TR-42: Engineering Committee on Premises Telecommunications Cabling

Date: June 12, 2007

Subject: Clarification on De-rating Guidance

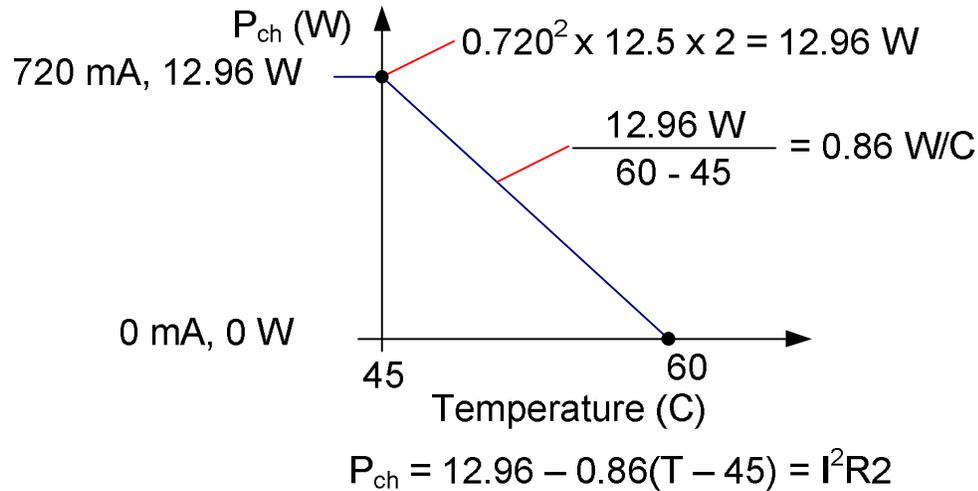
Please see the attached graph. Does this graph accurately reflect your de-rating guidance per the technical contribution?

The graph does not reflect our recommended de-rating. Instead, TR-42.7's de-rating recommendation for the temperature range of 45 °C to 60 °C is intended for high power applications of 30 watts over two pairs, not 12.96 watts over two pairs as shown in the diagram. Note that the temperature de-rating break point for 12.96 watts actually occurs at a higher temperature. The de-rating of the total power to a cable bundle is still under study and is intended to limit the maximum total power into a cable bundle; not the power of each individual PSE or PD.
